The FCC requested additional information in reference to the submission for certification of the Automatic Power Phalcon-2000 Radar Beacon. The data below and the attached data plots revises paragraphs 4.1.2, 4.3.1, and Appendix D of the SwRI test report entitled ‘‘FCC Measurement and Technical Report on the Automatic Power Incorporated Phalcon-2000 Radar Beacon,’’ dated November 1999 (report no. 99/129).

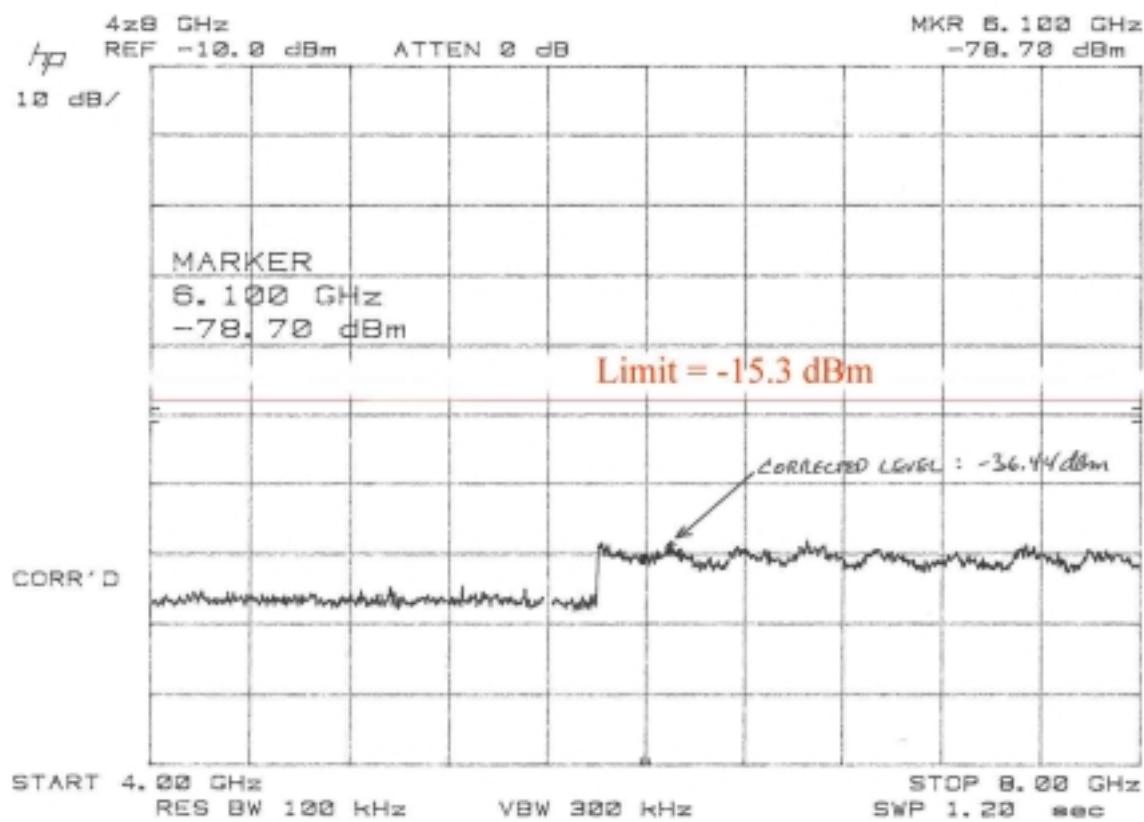
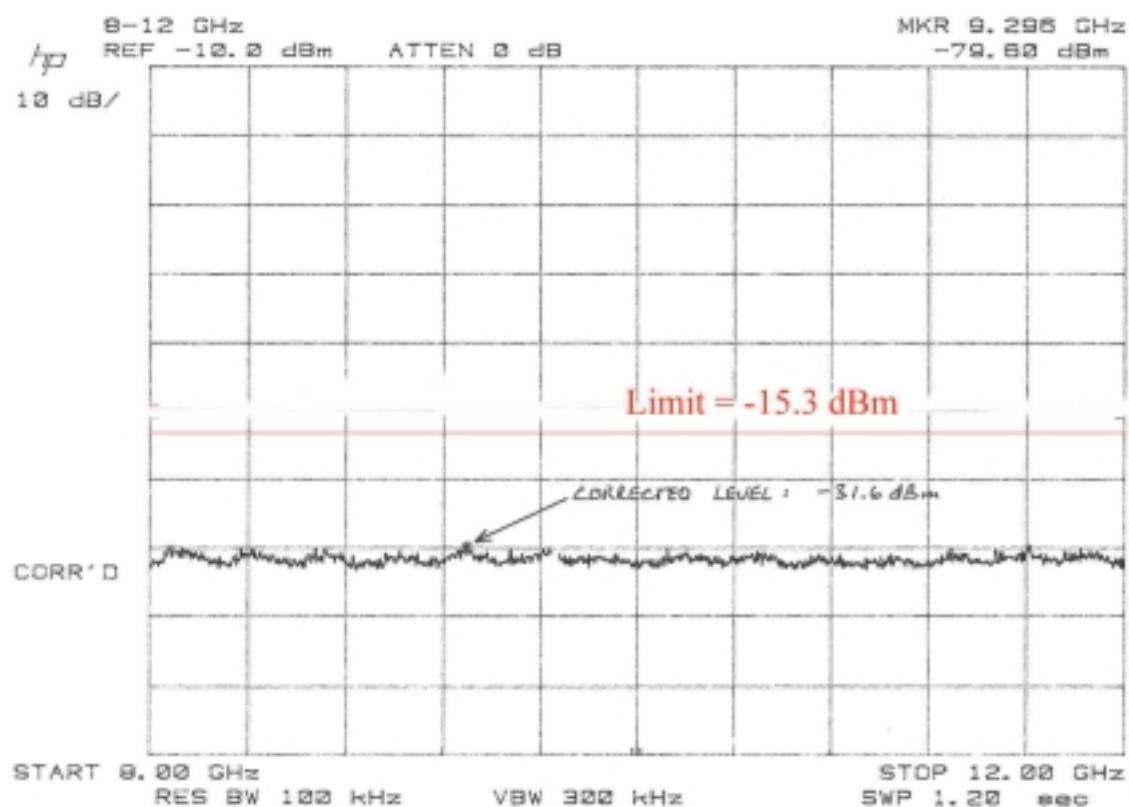
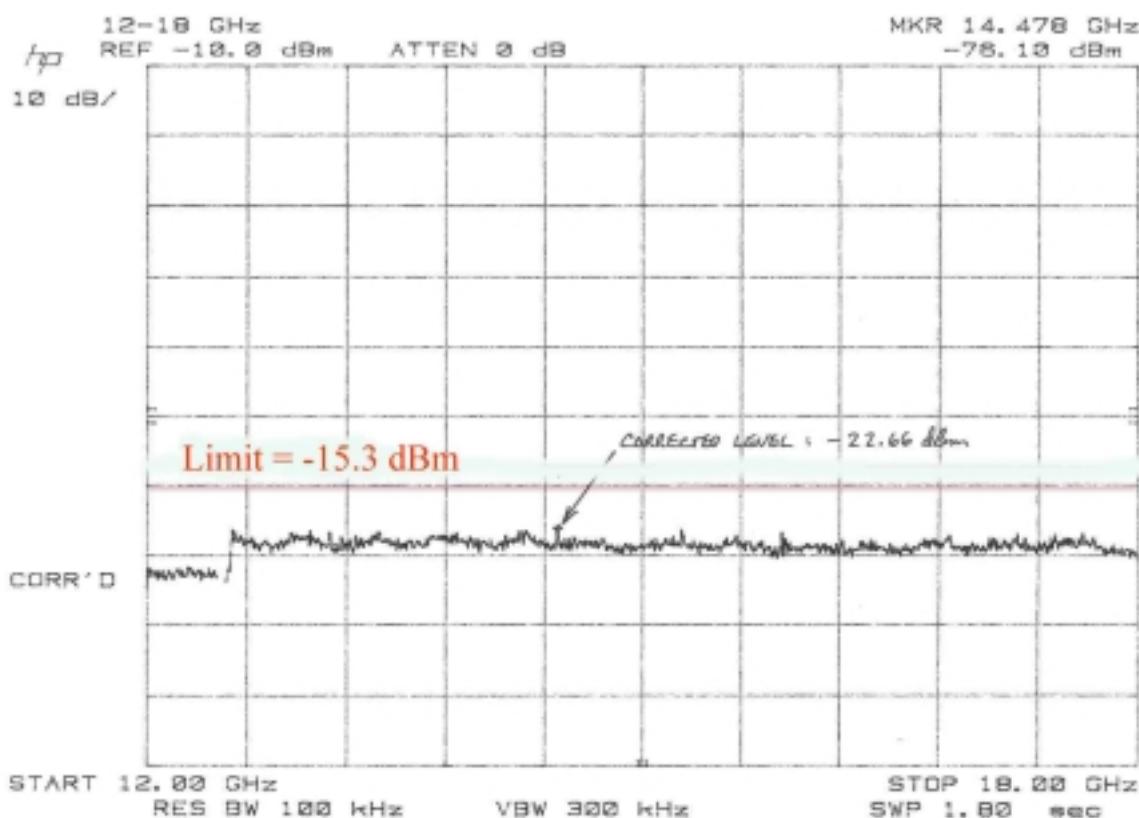
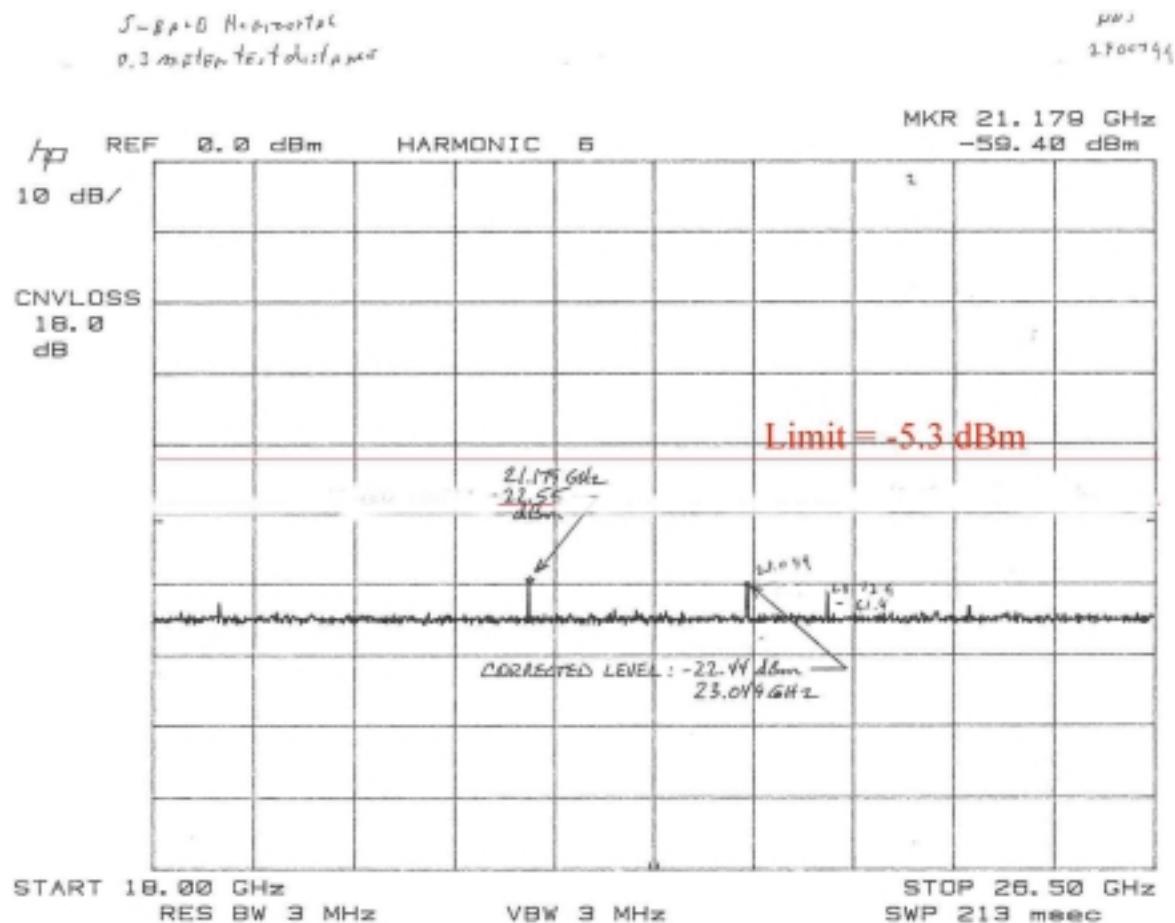
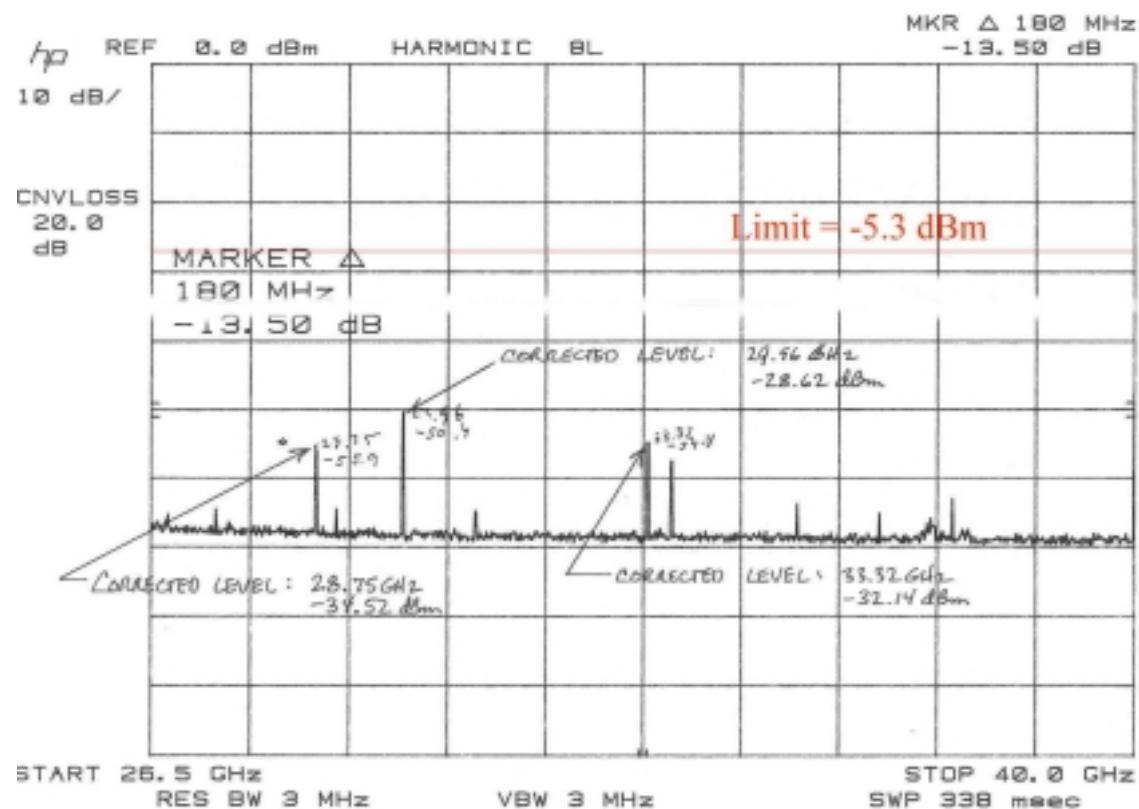
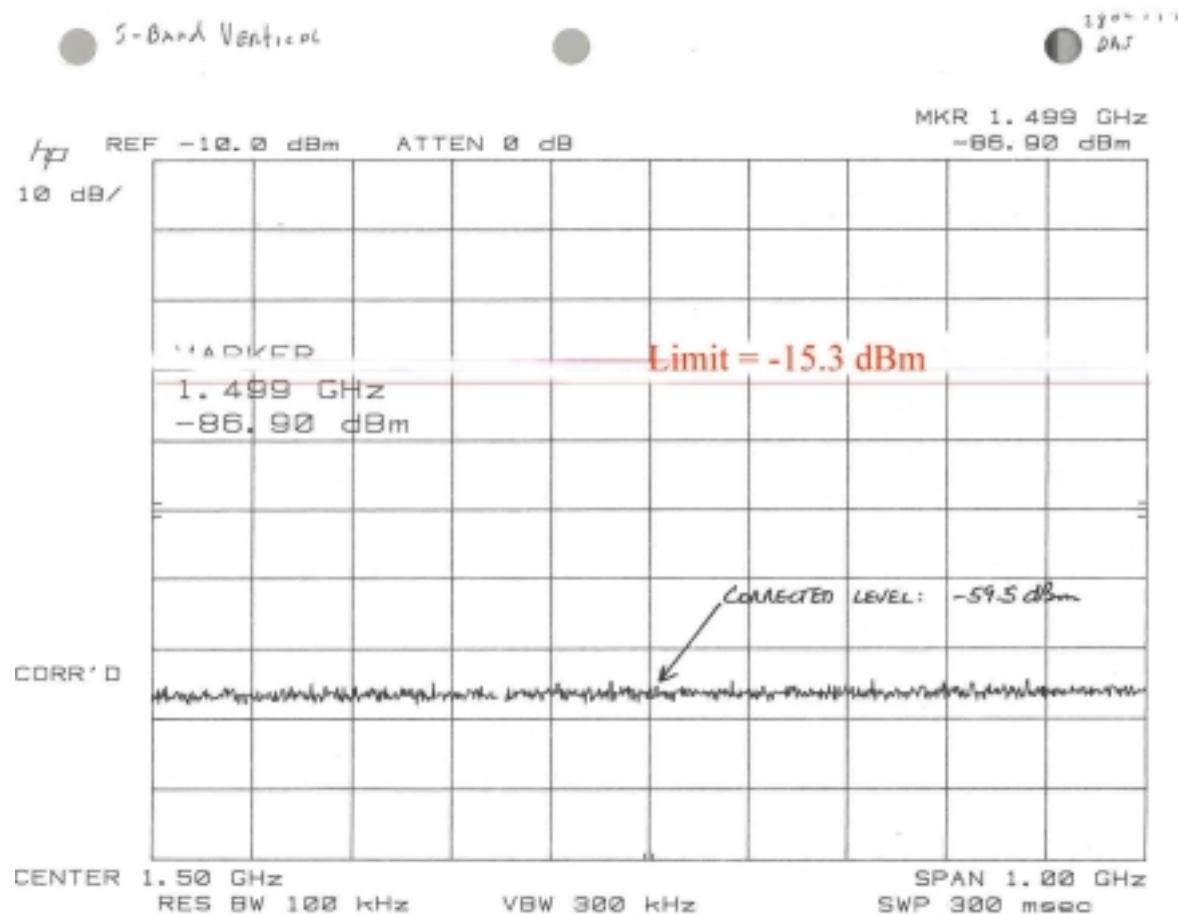
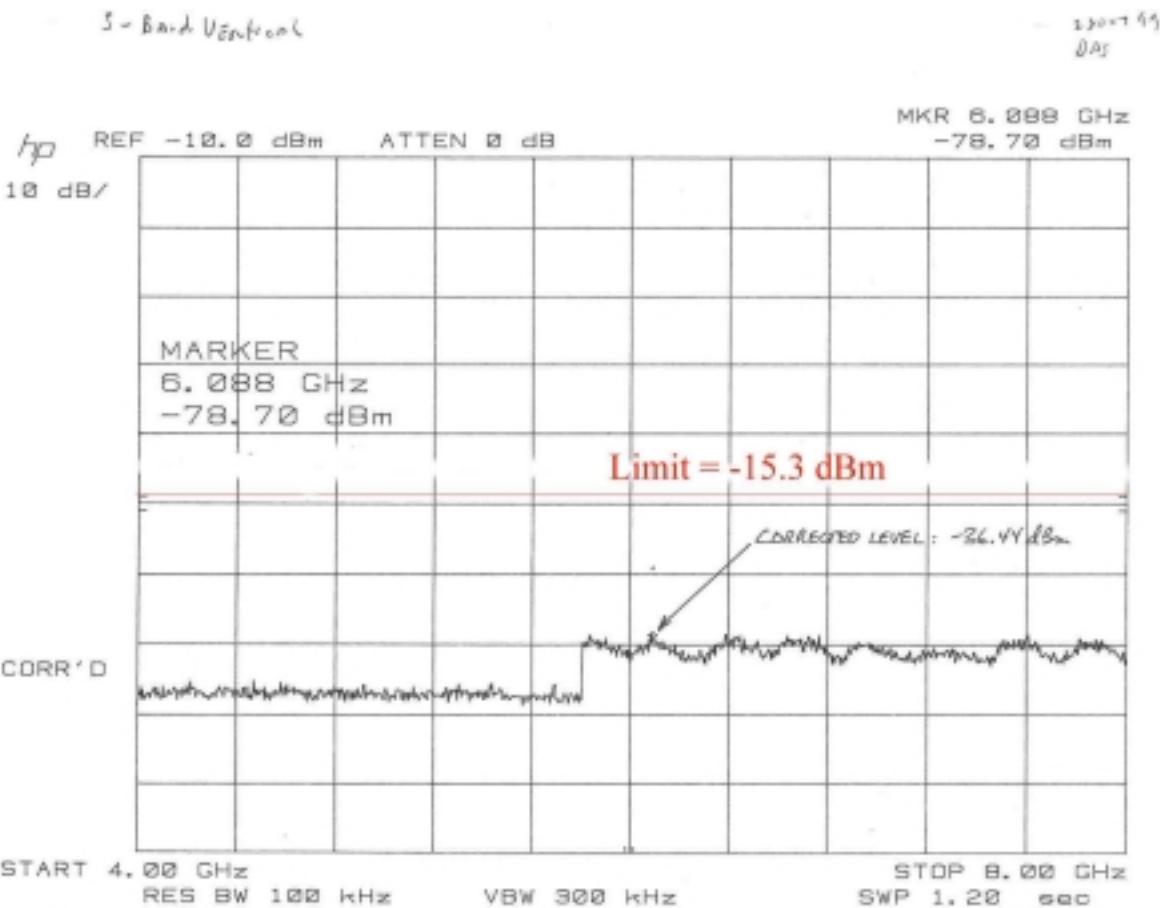
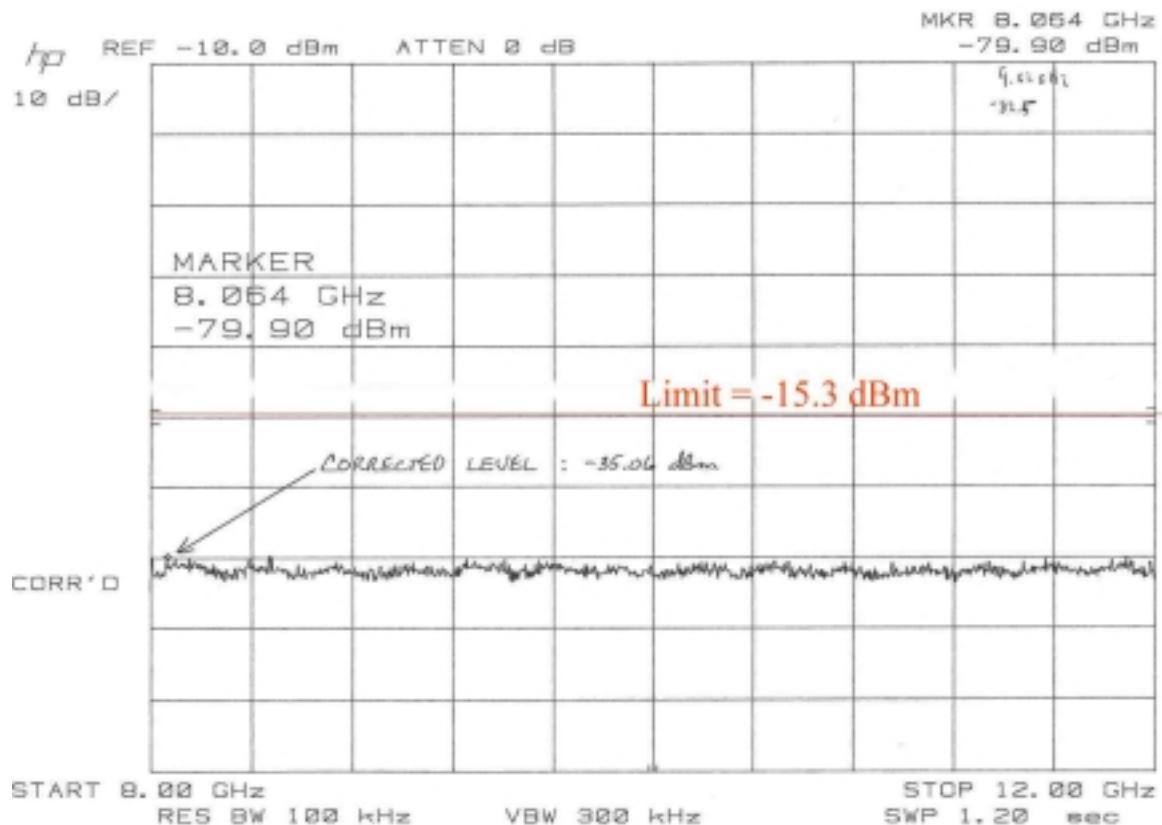
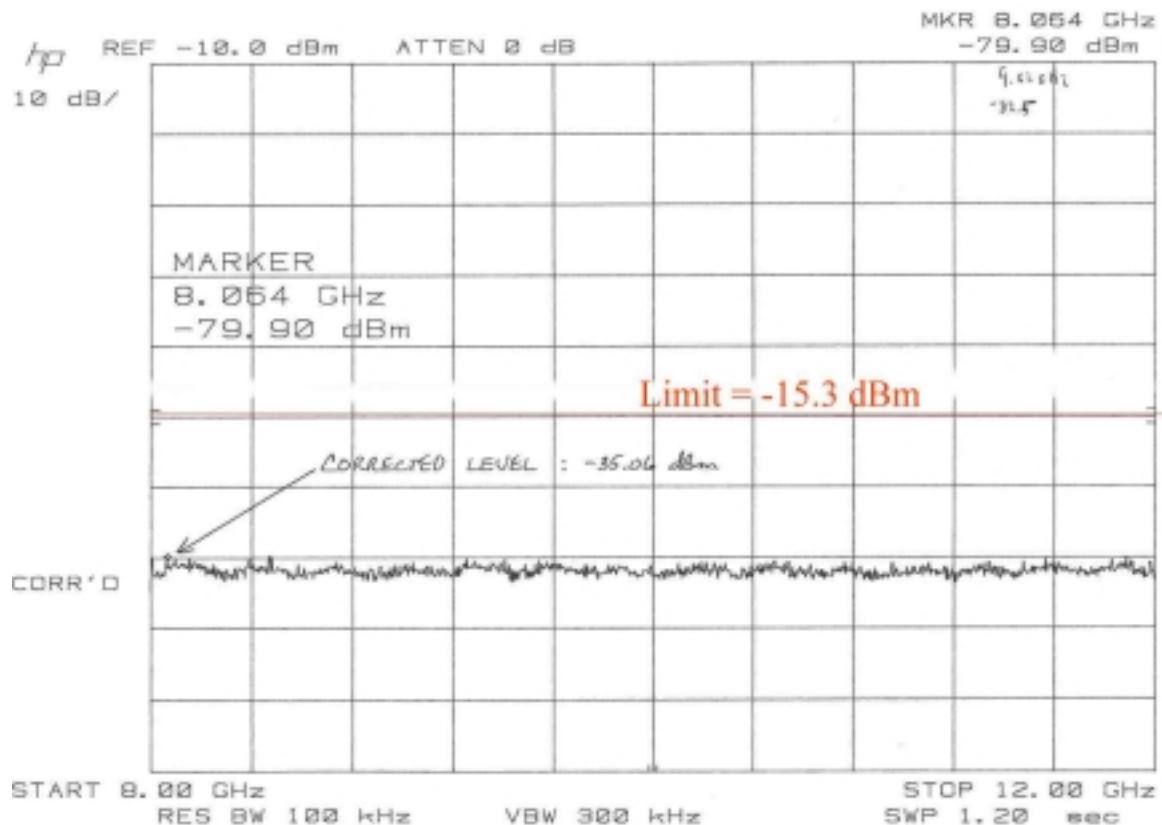
Question 2 from the FCC: *The attenuation specification for radiated spurious emissions should be computed on the basis of the (average) ERP. Please do this and report the results on that basis.*

The harmonics and spurious emissions were required to be 43 plus 10 log (average ERP in watts) dB below the fundamental emission:

Band		Limit
S	$43 + 10 \log (.238) \text{ dB} =$	36.8 dB (below fundamental)
X	$43 + 10 \log (.351) \text{ dB} =$	38.5 dB (below fundamental)

The data plots showing the radiated spurious emissions have been revised to show the corrected attenuation levels based on average ERP. These plots are attached to this letter. The worst case emission level was detected from the S-band, horizontal polarization, at 14.478 GHz, and was 5 dB under the limit.
